# Alpha Clothing (New) (Extension)

13 August 2025

## Structural Inspection Report

Fig:  $f'_c$  consider in FEA model

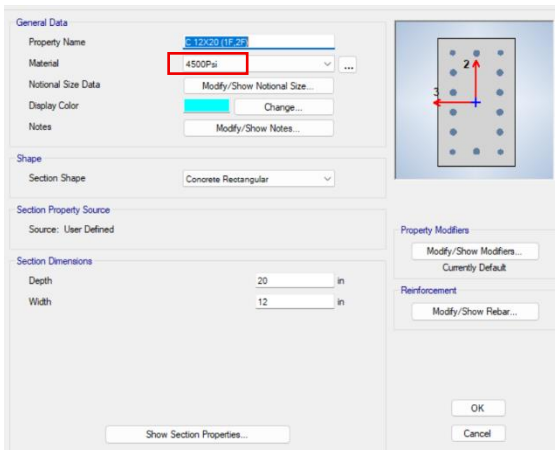
- The Response Modification Coefficient ( $R = 5$ ) has been considered in the design which indicates the IMRF framing system, but the required detailing and serviceability checks were not provided in the report.
- Six sets of cylinder test reports (column=2 set, Beam & Slab = 1 set, Foundation=3 set) were available which does not comply with the testing-frequency requirements of BNBC 5.12.1. In the design report,  $f'_c$  was considered 27.58 MPa for the column & foundation and 24.14 MPa for the beam & slab. The FEA model, however,  $f'_c$  was considered 31 MPa.
- In the design report, the average allowable bearing capacity of the foundation at the 8 ft level from EGL (F.S.= 2.5) is considered 4.69 ksf. but the required calculations were not provided in the report, also the lateral load was not considered in the foundation adequacy check.

The building engineer is required to verify the in-situ concrete strength by extracting 100mm diameter cores from four columns (preferably from the lower tier of the building), as well as from the beam and slab, or by referring to existing cylinder test reports from the specific concrete mix ratio and address all the inconsistencies in the revised EA report and submit the revised EA to RSC.

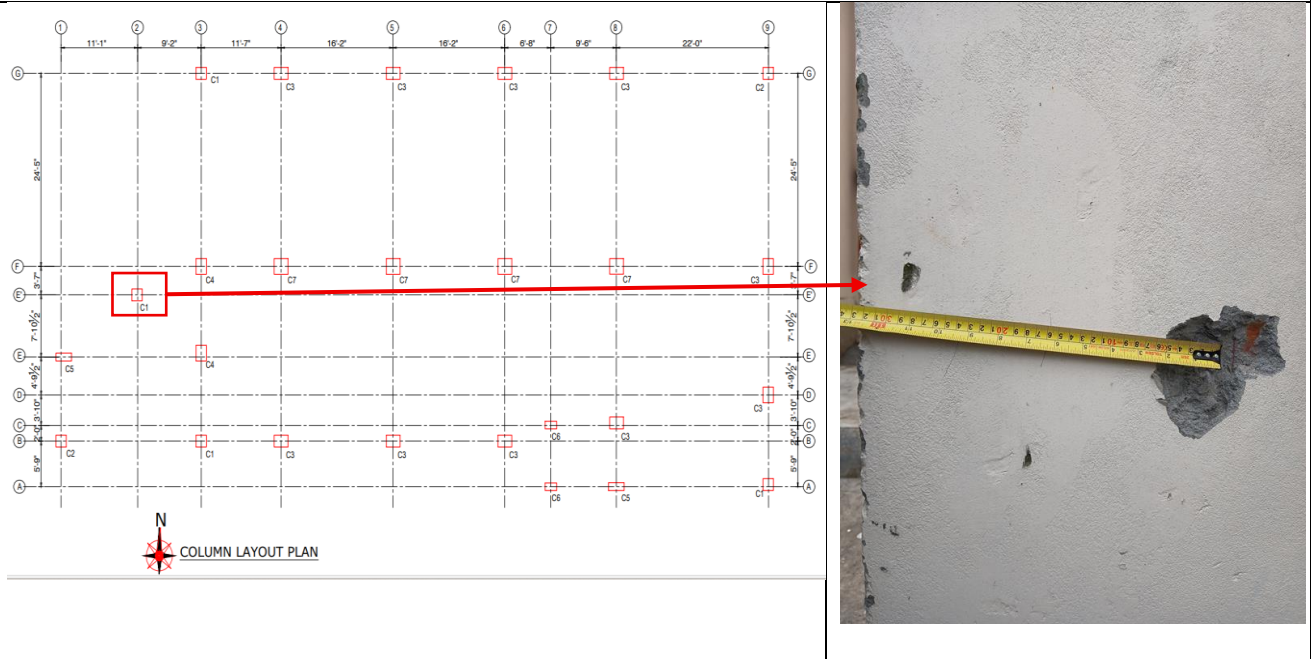
**Description:** At grid E-01, the C5 column at ground floor was found 15"x27" instead of 12"x27", and the rebar was found 20 nos instead of 18 nos.

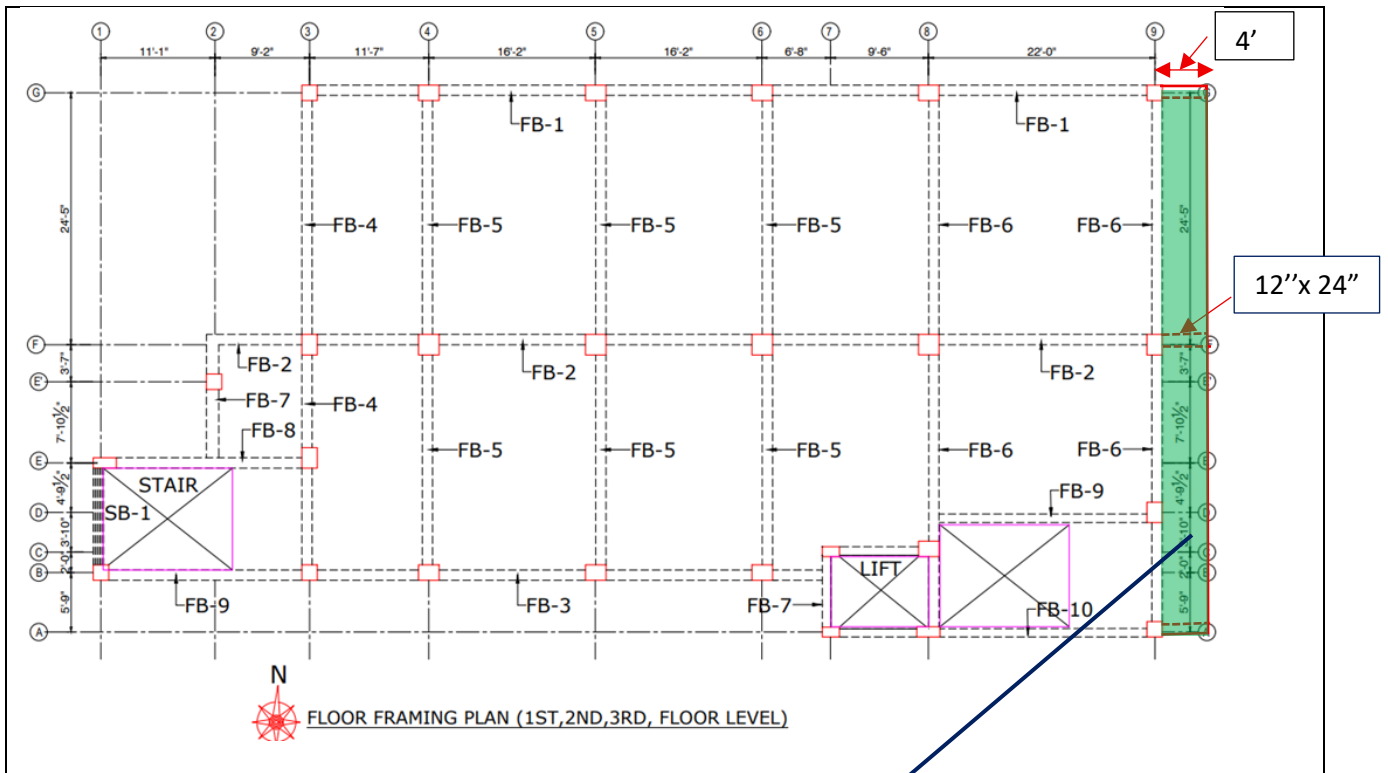
**Description:** At grid E'-02, the C1 column at ground floor was found 12"x18" instead of 18"x18", and the rebar was found 10 nos.. instead of 12 nos.

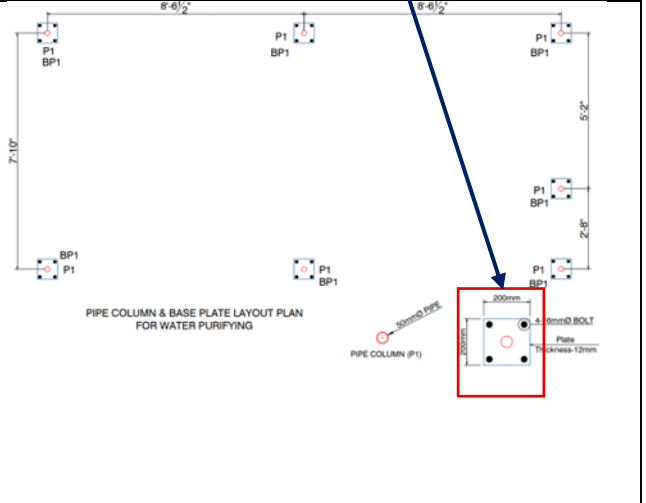
**Description:** A cantilever portion on the 1st floor was found on-site, which was not mentioned in the as-built drawings. The building engineer is required to survey the structures and prepare comprehensive as-built drawings, including necessary foundation details.

**Observation-06: Mismatch in as-built drawing (Compressor Room-2)**

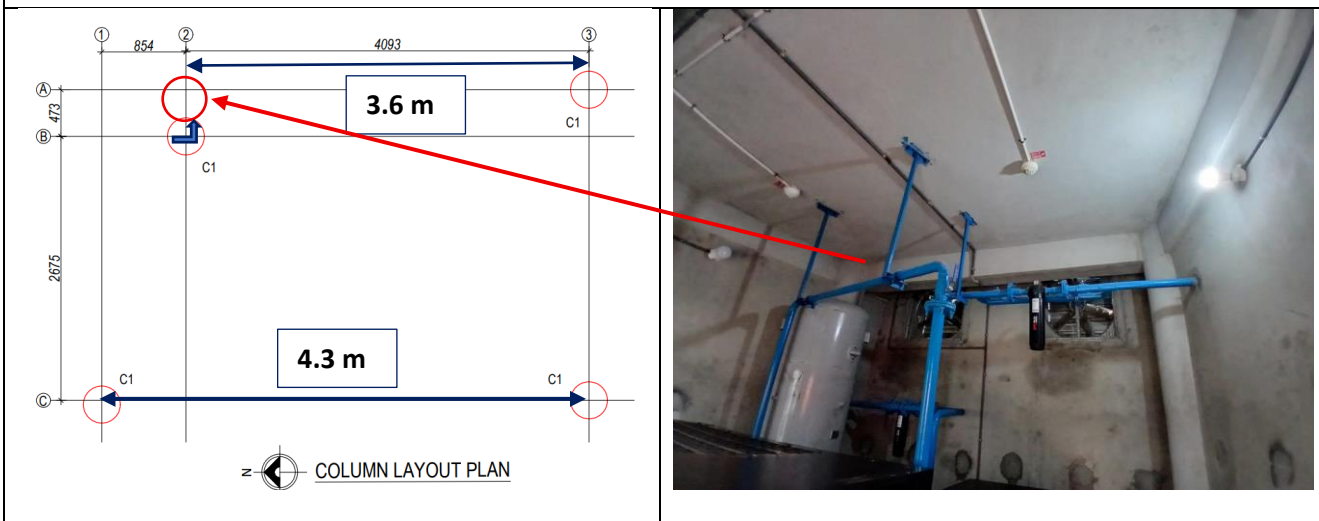
**Description:** During the inspection, mismatch was found in grid dimension and column layout. The building engineer is required to survey the structures and prepare comprehensive as-built drawings, including necessary foundation details.
